SUNDRY NOTICES AND REPORTS ON WELLS (DO NOT USE THIS FORM FOR PROPOSALS TO DRILL OR TO DEEPEN OR PLUG BACK TO A DIFFERENT RESERVOIR. USE "APPLICATION FOR PERMIT" (FORM C-101) FOR SUCH PROPOSALS.)		WELL API NO.
1. Type of Well: Oil Well ☐ Gas Well ☐ Other ☐		5. Indicate Type of Lease STATE ☐ FEE ☐
2. Name of Operator		6. State Oil & Gas Lease No.
3. Address of Operator		7. Lease Name or Unit Agreement Name
4. Well Location Unit Letter _____: _____ feet from the _____ line and _____ feet from the _____ line Section _____ Township _____ Range _____ NMPM _____ County _____		8. Well Number
11. Elevation (Show whether DR, RKB, RT, GR, etc.)		9. OGRID Number
		10. Pool name or Wildcat

1 API Number 30-015-50007		2 Pool Code 98220		3 Pool Name Purple Sage; Wolfcamp (Gas)	
4 Property Code 329348		5 Property Name POTATO BABY STATE COM			6 Well Number 906H
7 OGRID No. 229137		8 Operator Name COG OPERATING LLC			9 Elevation 3072.49'

POTATO BABY STATE COM #906H

Operator: COG OPERATING LLC 600 W Illinois Ave Midland, TX 79701	OGRID: 229137
	Action Number: 181975
	Action Type: [C-103] NOI Change of Plans (C-103A)

Potato Baby State Com 906H

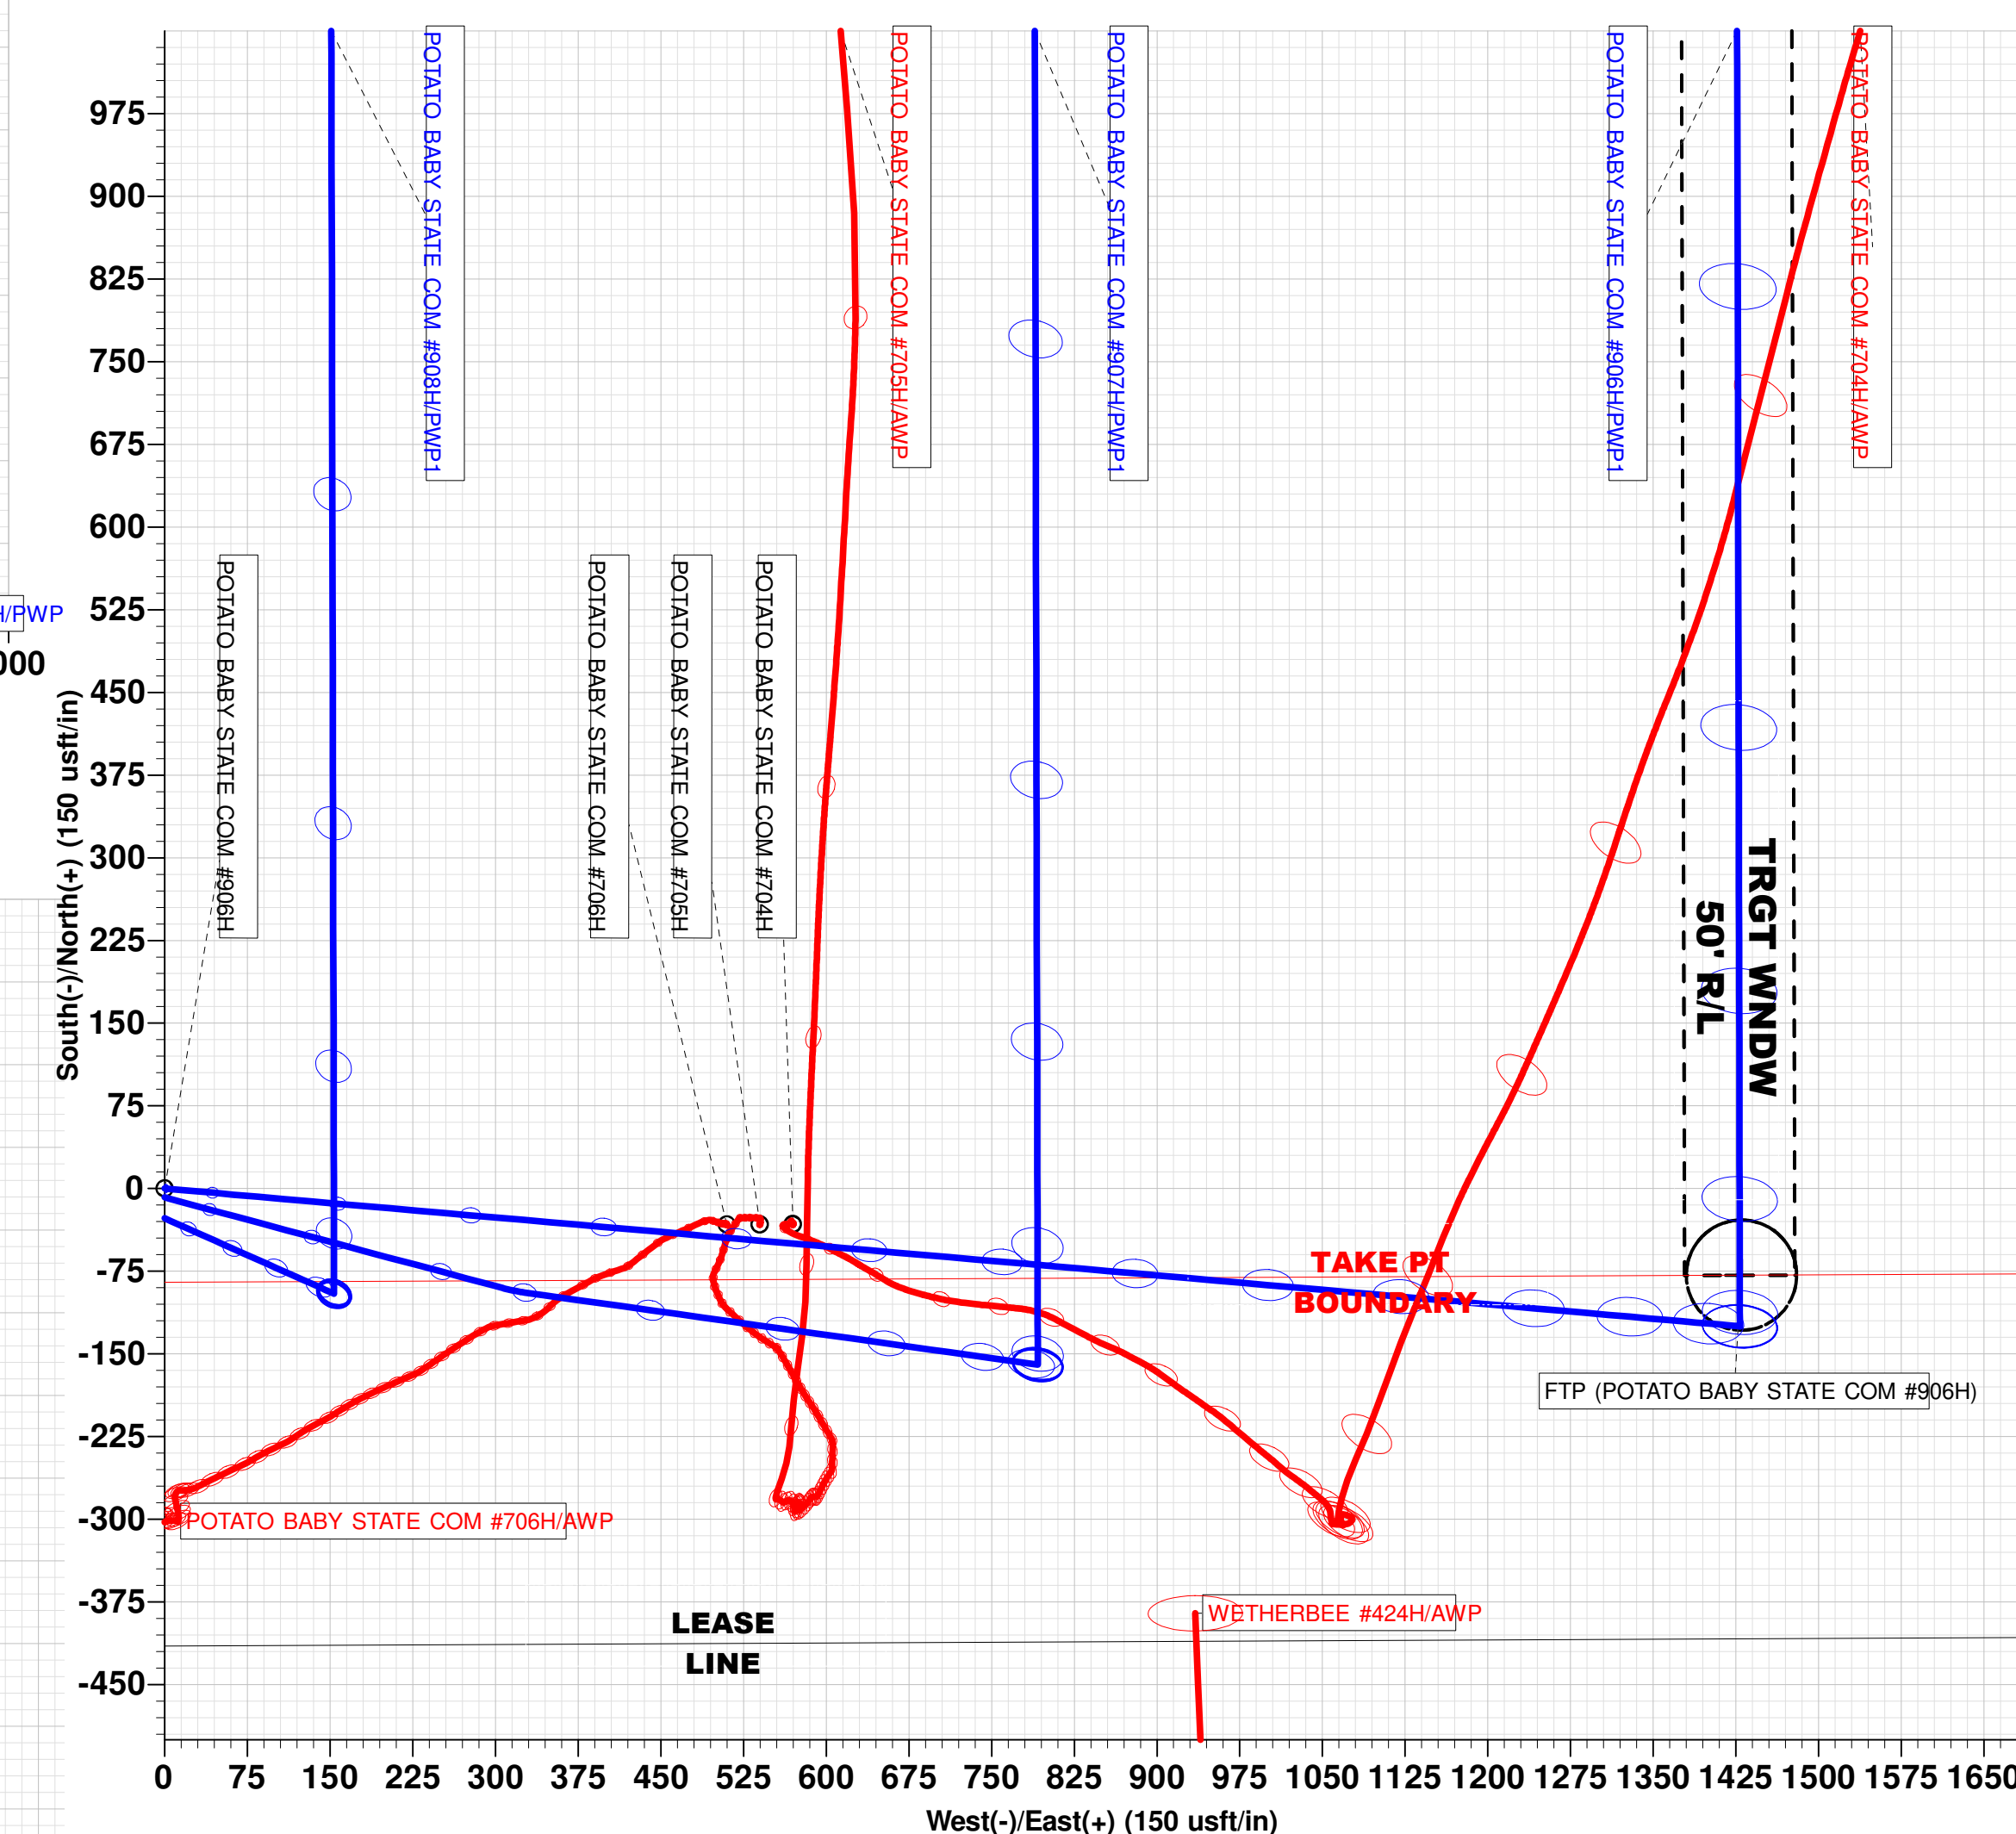
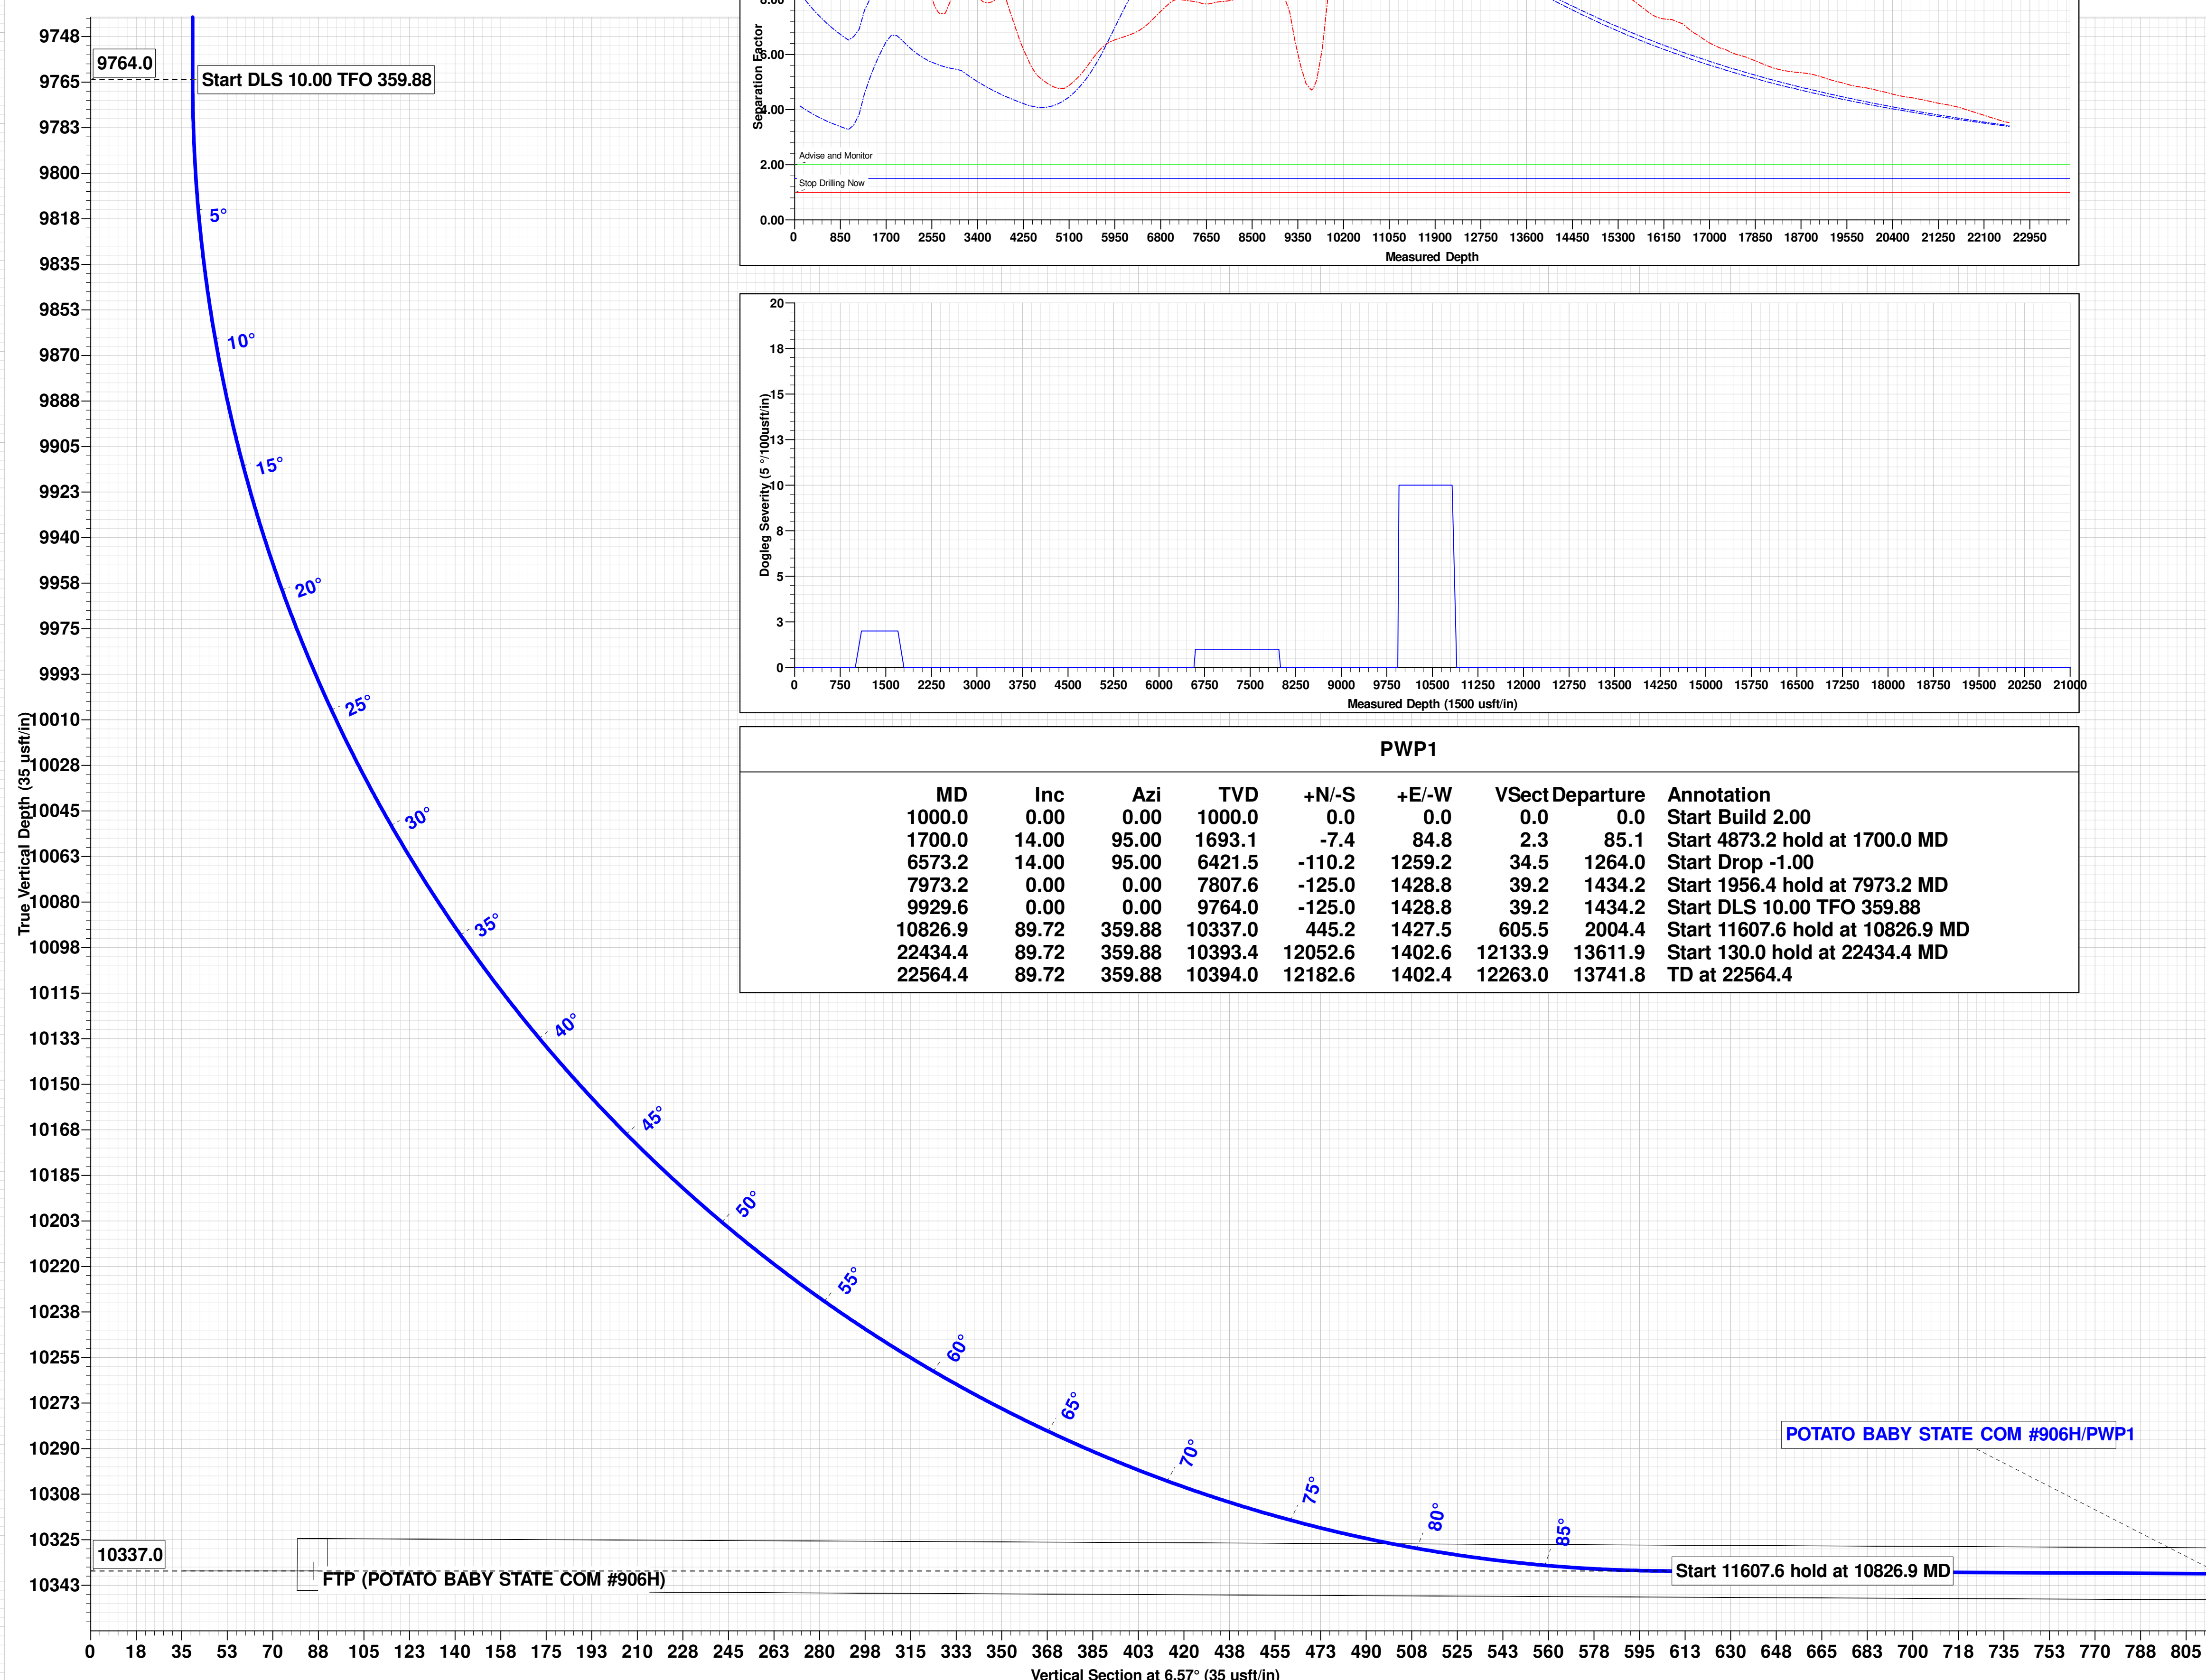
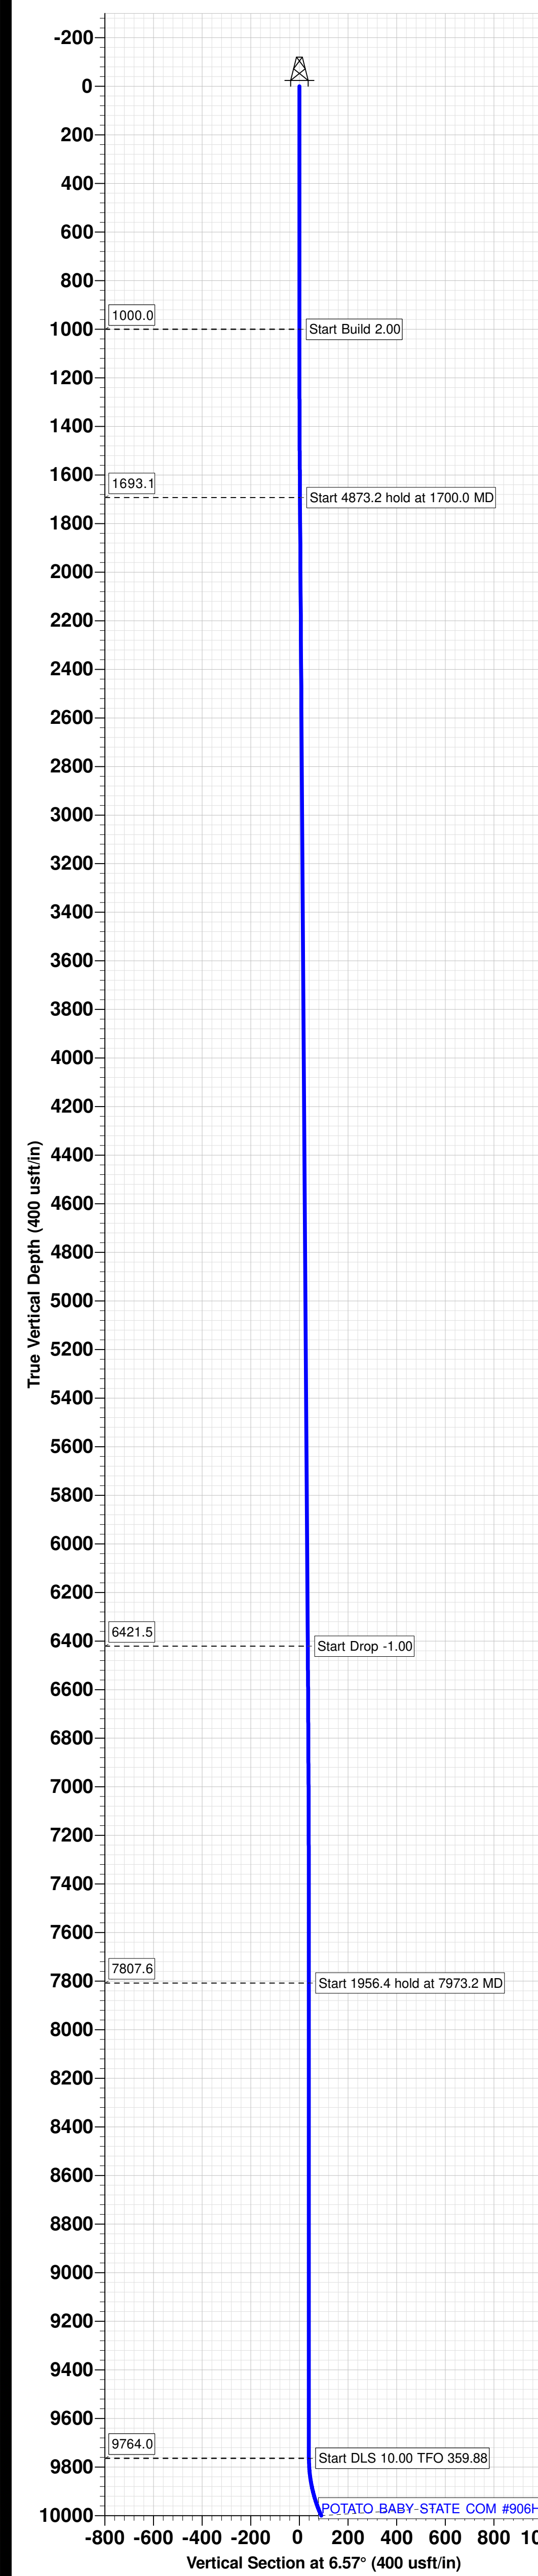
NOTICE OF INTENTION TO:		SUBSEQUENT REPORT OF:	
PERFORM REMEDIAL WORK ☐	PLUG AND ABANDON ☐	REMEDIAL WORK ☐	ALTERING CASING ☐
TEMPORARILY ABANDON ☐	CHANGE PLANS ☐	COMMENCE DRILLING OPNS. ☐	P AND A ☐
PULL OR ALTER CASING ☐	MULTIPLE COMPL ☐	CASING/CEMENT JOB ☐	
DOWNHOLE COMMINGLE ☐			
CLOSED-LOOP SYSTEM ☐			
OTHER: ☐	Change BHL ☒	OTHER: ☐

UL or lot no.	Section	Township	Range	Lot Idn	Feet from the	North/South line	Feet from the	East/West line	County
C	22	26-S	28-E		200'	NORTH	2245'	WEST	EDDY
